**PLANNING APPROVAL &
SUBDIVISION STAFF REPORT****Date: November 1, 2007**

<u>DEVELOPMENT NAME</u>	Sivaporn & Varin Nimityongskul
<u>SUBDIVISION NAME</u>	Nimit Subdivision
<u>LOCATION</u>	4567 Airport Boulevard (Southeast corner of Airport Boulevard and Summit Drive)
<u>CITY COUNCIL DISTRICT</u>	District 5
<u>PRESENT ZONING</u>	R-1, Single-Family Residential
<u>AREA OF PROPERTY</u>	1 lot / 0.8± Acres
<u>CONTEMPLATED USE</u>	Planning Approval to allow a meditation center in an R-1, Single-Family Residential district, and Subdivision approval to create one lot.
<u>TIME SCHEDULE FOR DEVELOPMENT</u>	Not provided.
<u>ENGINEERING COMMENTS</u>	Provide storm water detention for all impervious area in excess of 4000 sq ft constructed post-1984, when the storm water ordinance was implemented. It is the responsibility of the applicant to look up the site in the City of Mobile (COM) GIS system and verify if NWI wetlands are depicted on the site. If the COM GIS shows wetlands on the site, it is the responsibility of the applicant to confirm or deny the existence of wetlands on-site. If wetlands are present, they should be depicted on plans and/or plat, and no work/disturbance can be performed

SITE PLAN

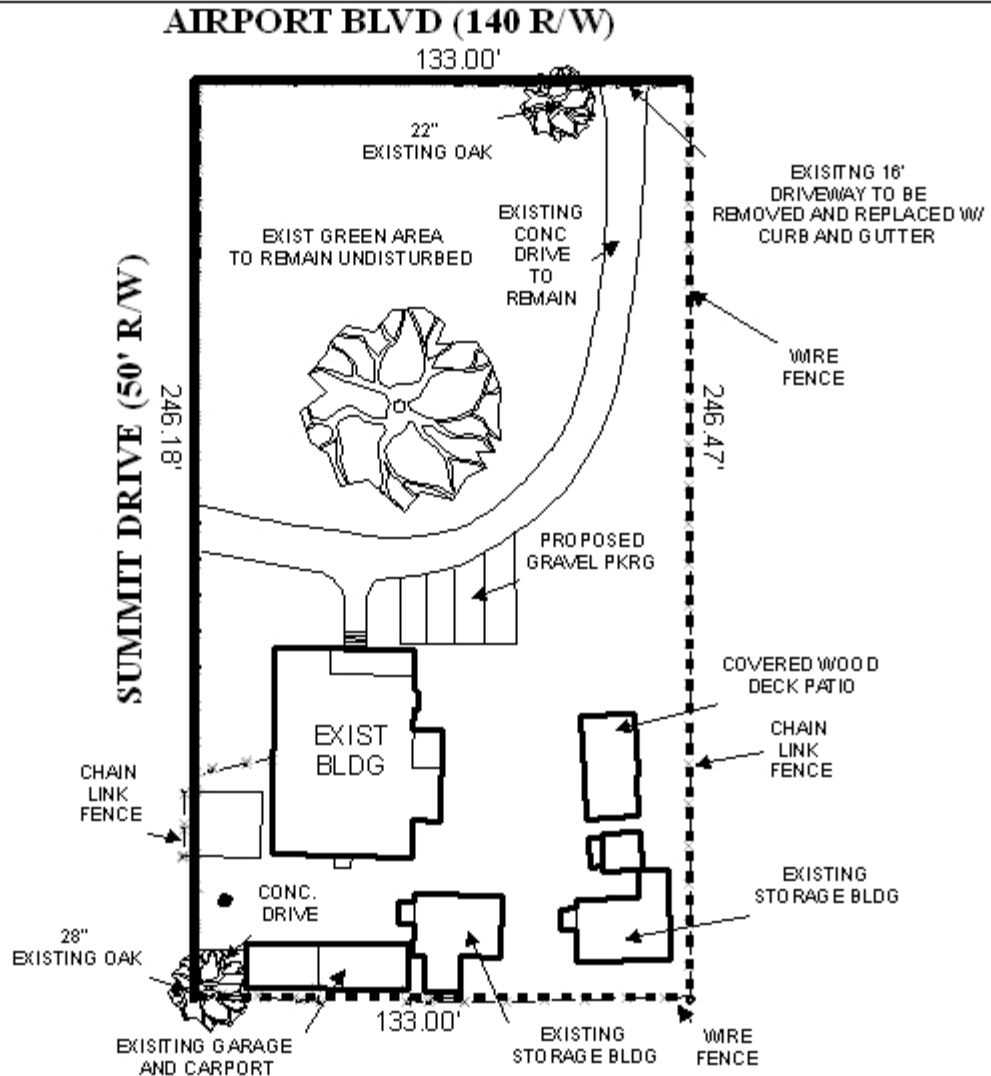
Access management is a concern due to the fact that the lot has frontage on a major street and a minor street that is lined with residences. It appears that the site currently has one curb-cut onto Airport Boulevard and three curb-cuts onto Summit Drive. Normally, a lot of this size would be limited, perhaps, to one curb-cut onto Airport Boulevard and one curb-cut onto Summit Drive, or preferably two curb-cuts onto Summit Drive and no curb-cuts onto Airport Boulevard.

The 25-foot minimum building setback line from all street frontages is not shown on the preliminary plat or Planning Approval site plan but would be required on the final plat and site plan, if approved.

Section V.D.6. of the Subdivision Regulations states that "*where necessary by reason of curb radii, property lines at street intersection corners shall be arcs having radii of at least 10 feet, or*

shall be chords of such arcs.” The Subdivision plat and Planning Approval site plan should be revised to reflect this requirement of the Subdivision Regulations.

Regarding the site improvements, it appears that the only improvements proposed by the applicant include the provision of 4 parking spaces with a crushed gravel surface, and alteration of the curb-cut onto Airport Boulevard to meet city standard. The proposed parking surface would not meet Zoning Ordinance requirements (which requires a paved surface), thus a variance would be required. The existing concrete driveway, ranging from 9 to 12 feet in width, would also not meet the requirements of the Zoning Ordinance, and would also likely not comply with the 2003 International Fire Code regarding fire truck access.

As this use would be the first non-residential use of the site, full compliance with the tree and landscaping aspects of the Zoning Ordinance would be required. A privacy fence, in conformance with Section 64-4.D.1., should also be provided where the site abuts existing single-family residences to the East and South.

- 1) The proposed use, and subsequent required modifications to the site and the building, may preclude any future single-family residential use of the site, and set the stage for future rezoning or use variance requests;
- 2) Site plan does not reflect compliance with the parking surface and maneuvering requirements of the Zoning Ordinance;
- 3) Site plan does not reflect compliance with the tree and landscaping requirements of the Zoning Ordinance; and
- 4) Site plan does not reflect compliance with the buffering requirements of the Zoning Ordinance.
